Alachua County Budget and Fiscal Services Procurement

RE: Addendum #5
BID 20-957 Poe Springs Boardwalk Improvements

SHEET TITLE: BOARDWALK REST AREA DETAILS		DATE: APRIL 2020
CLIENT: ALACHUA COUNTY PARKS & CONSERVATION LANDS	PROJECT: POE SPRINGS PARK IMPROVEMENTS	PROJECT NO: 338-19-09
SHEET NO: C4.4

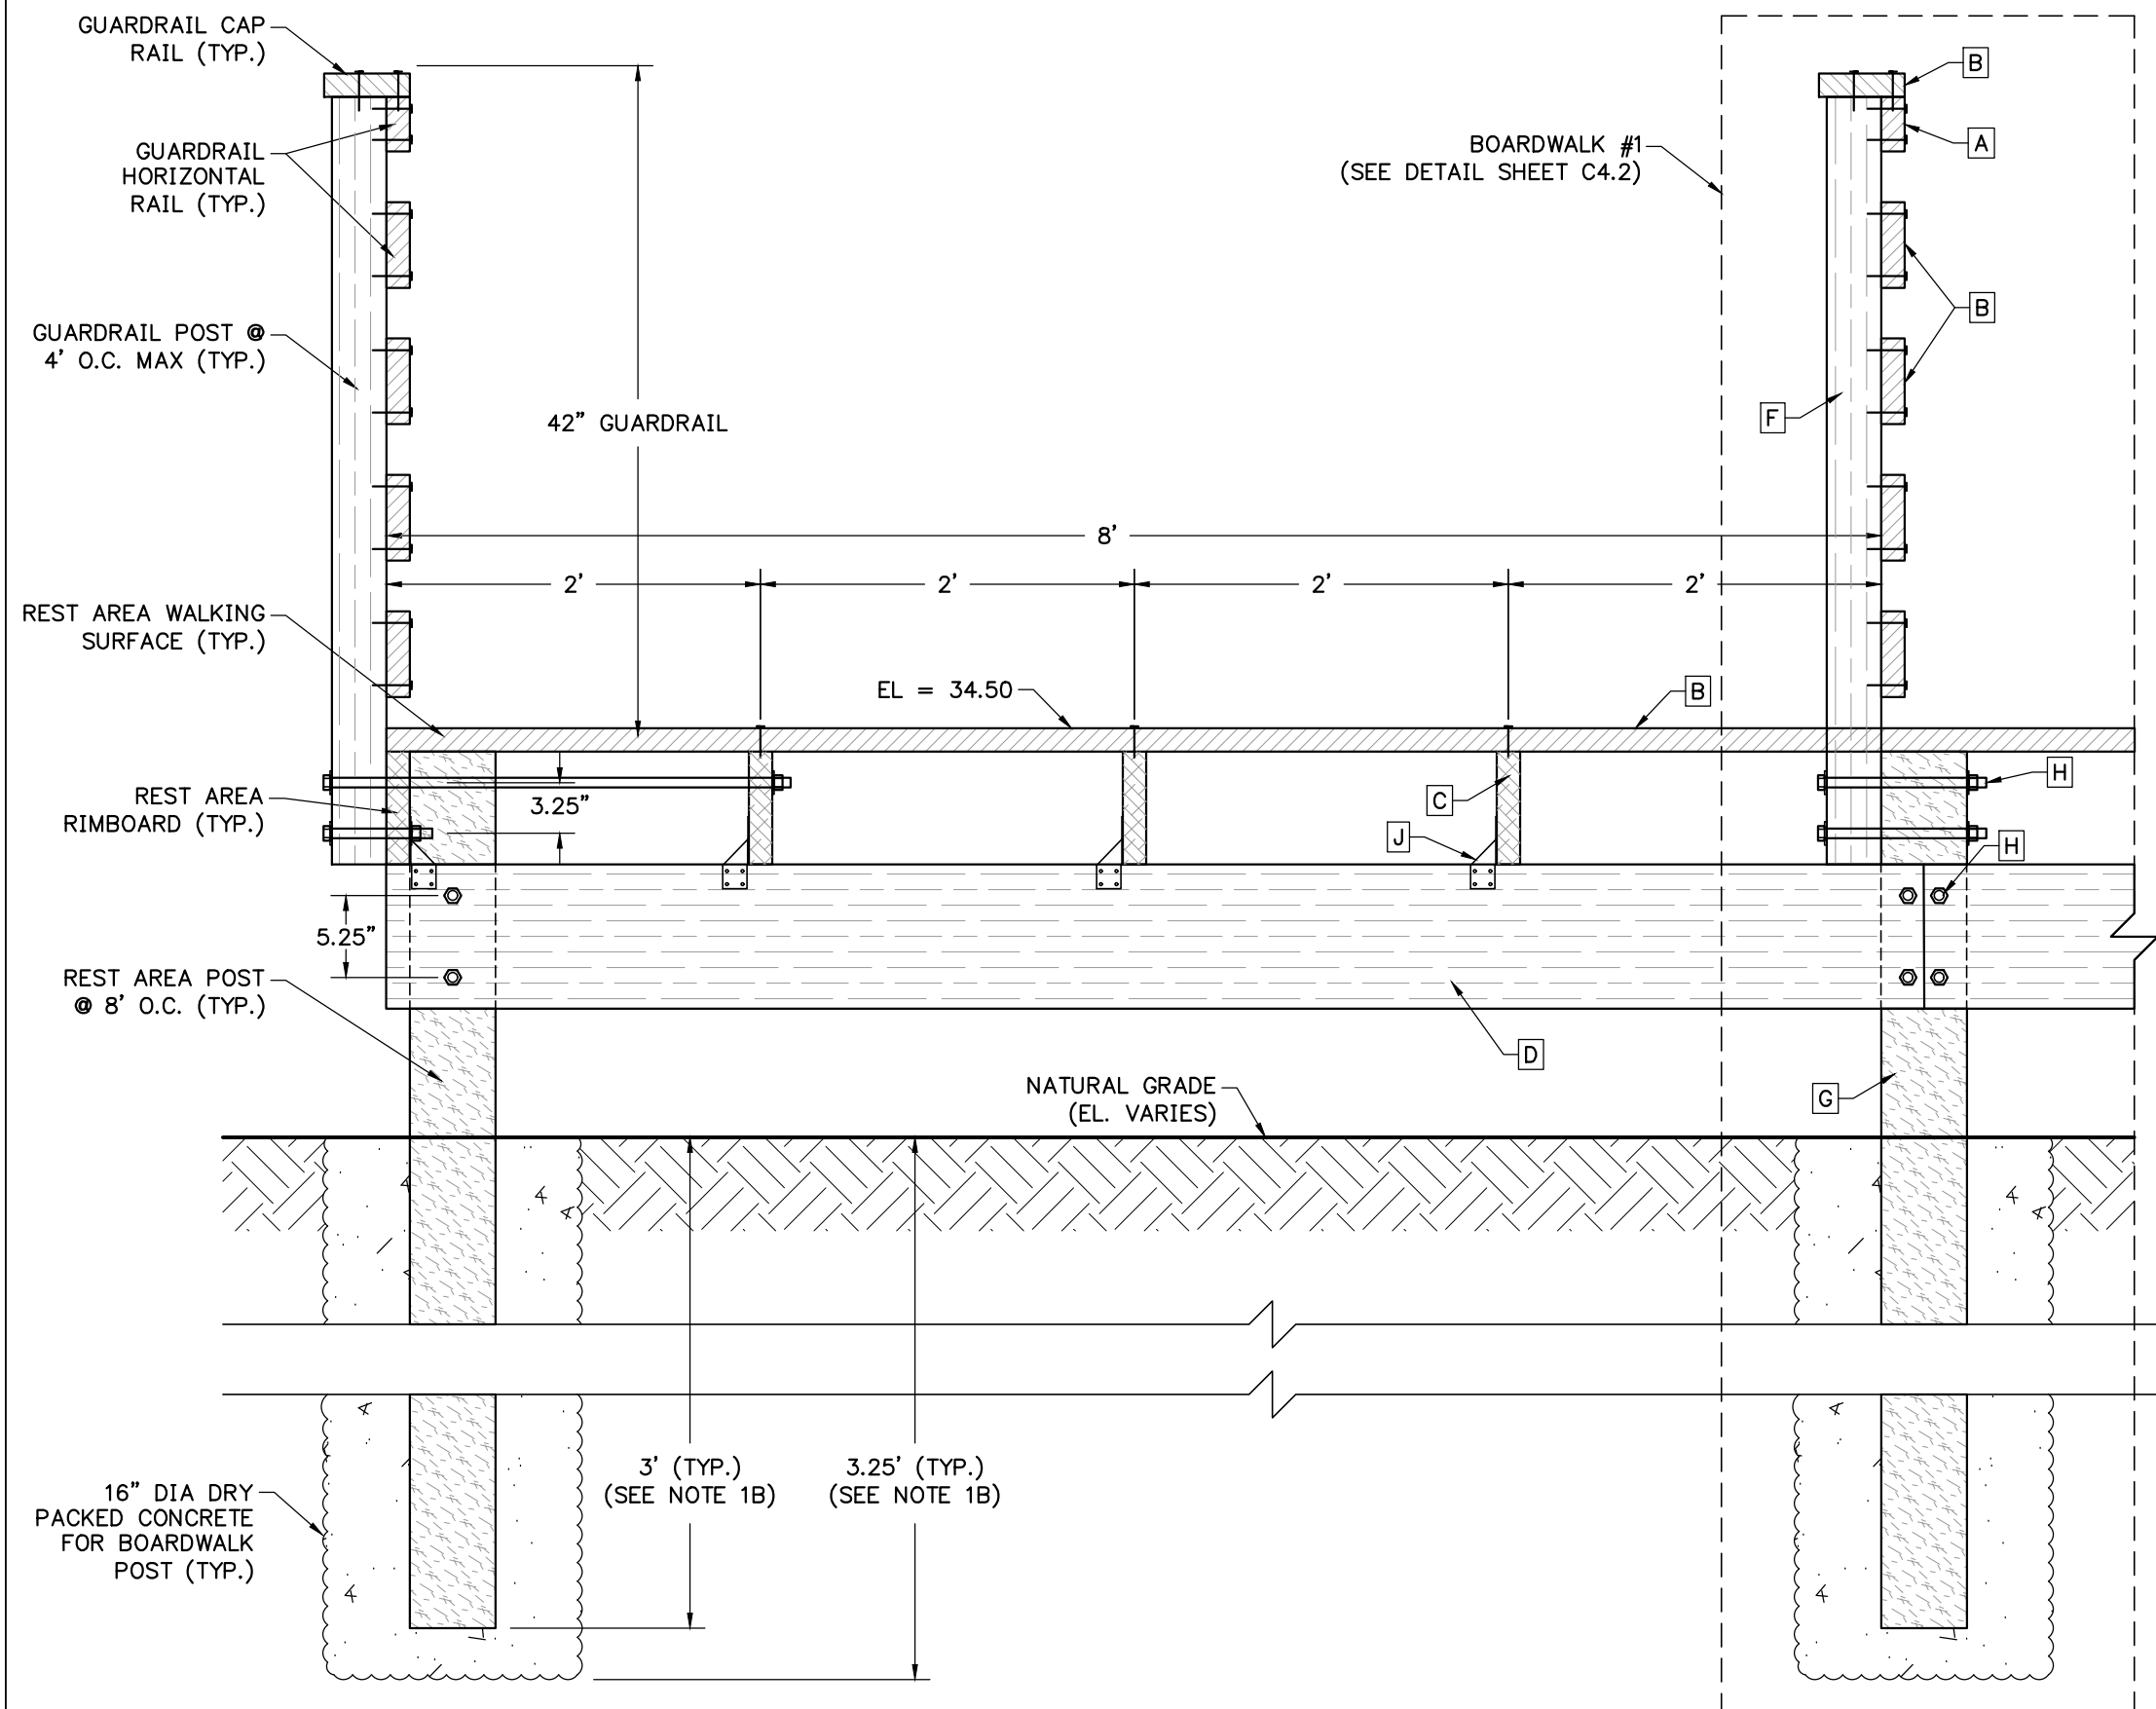
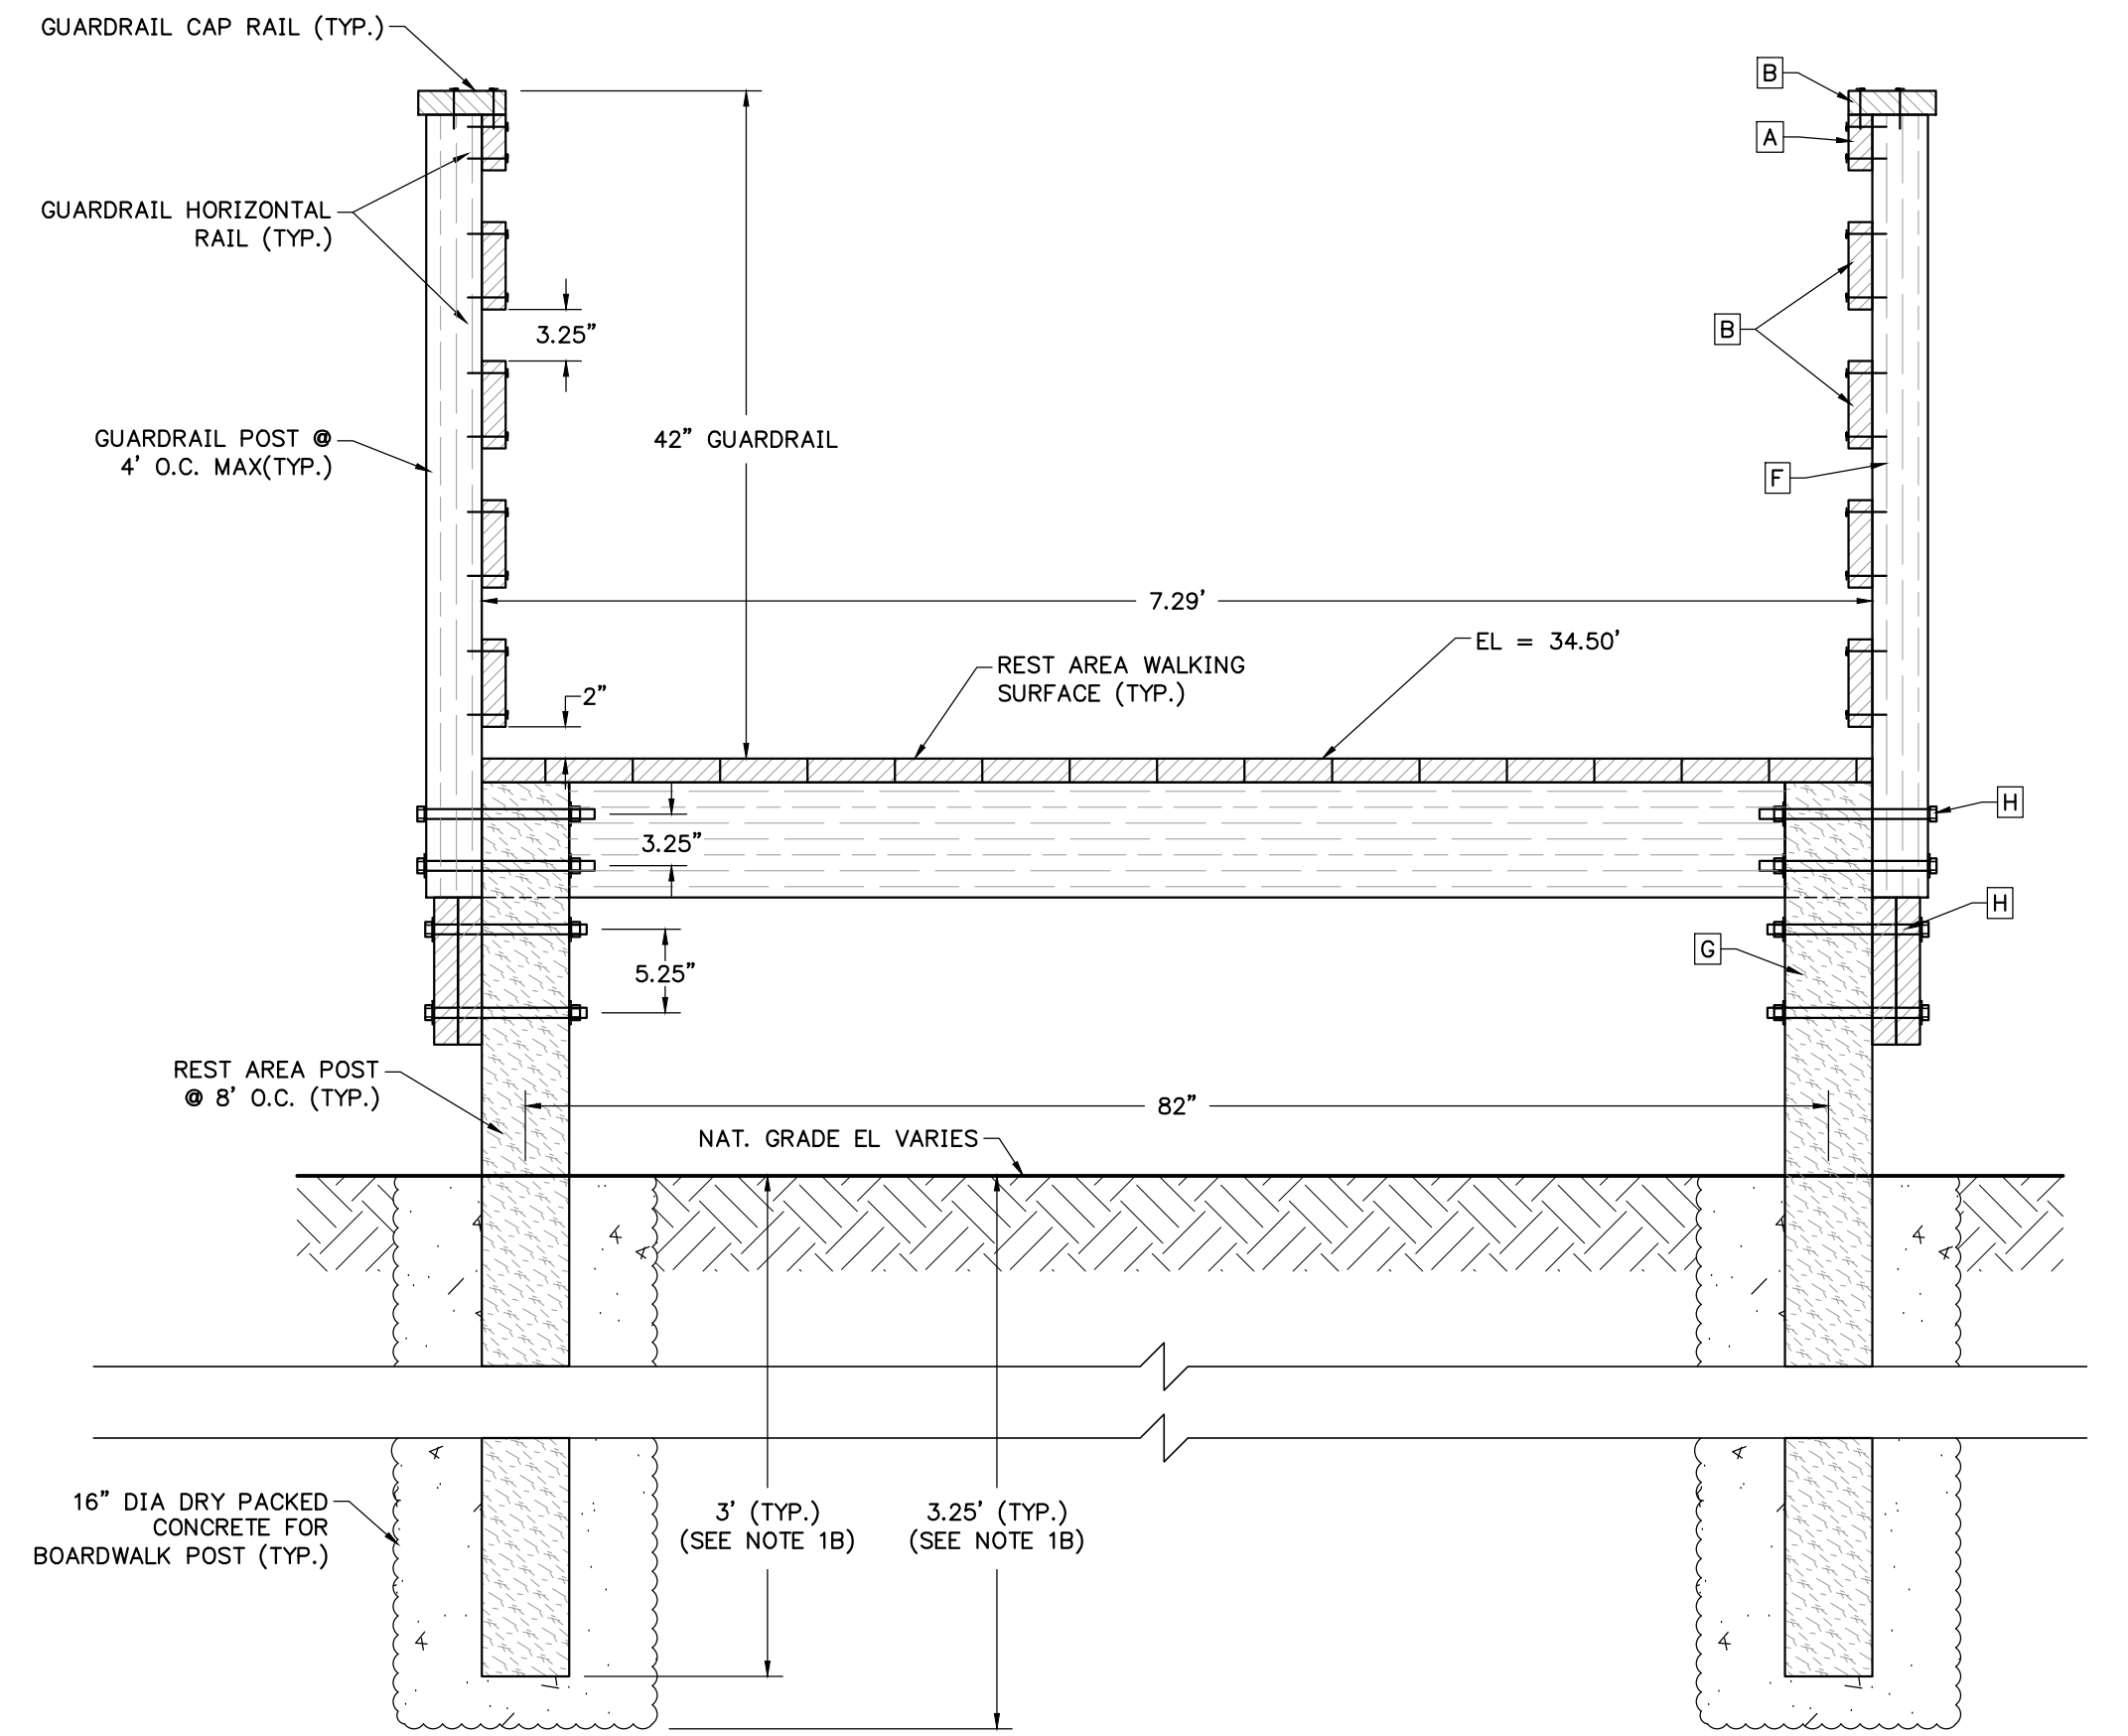
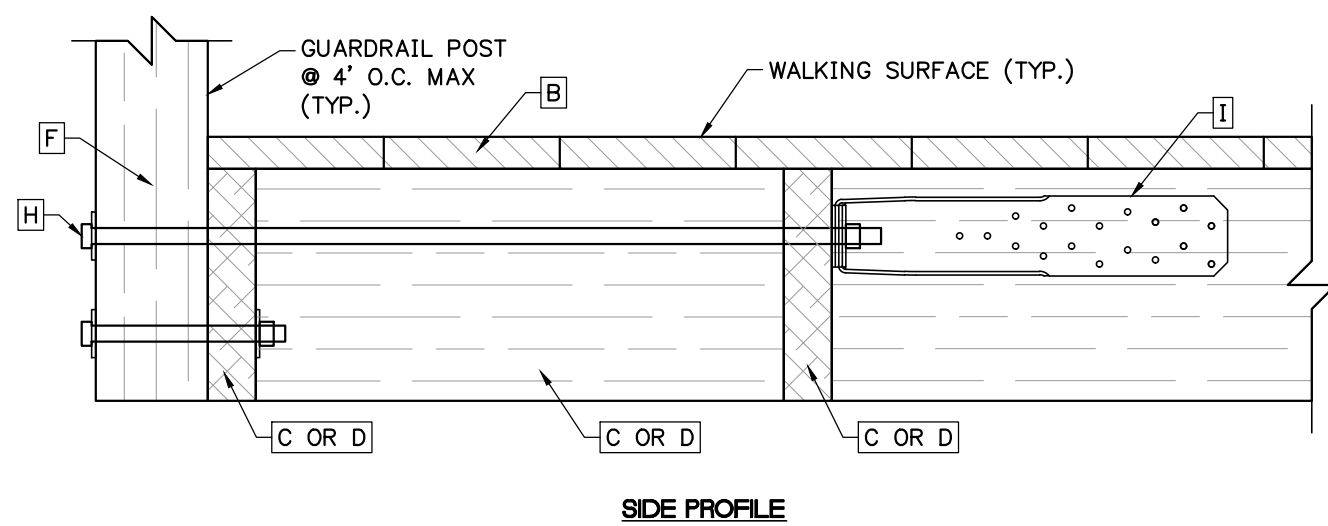
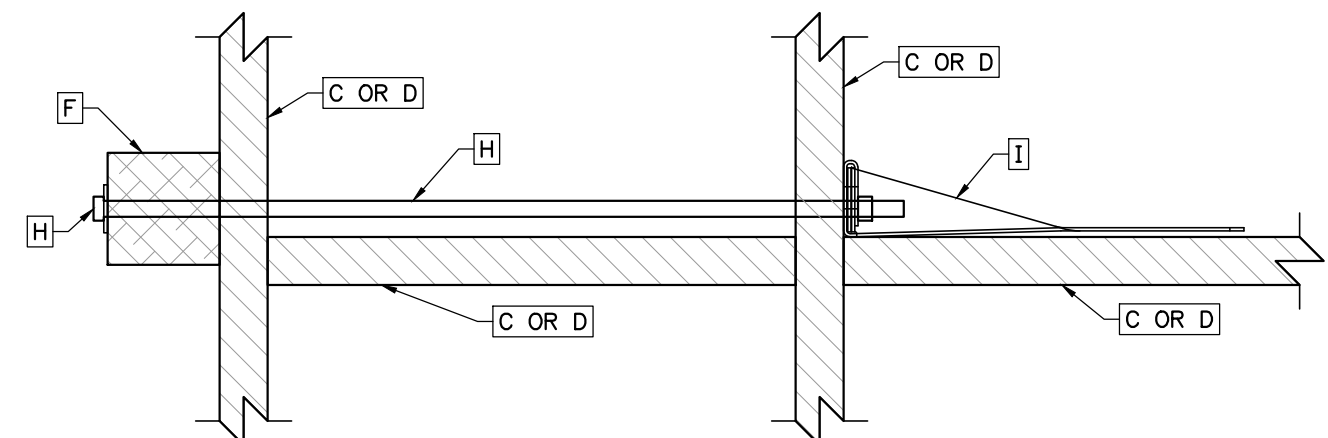
Q #6: Please see attached reference from plans for Boardwalk Rest Area – C4.4 Sheet is not in the plan set for this detail.

A #6: See Attached plans.
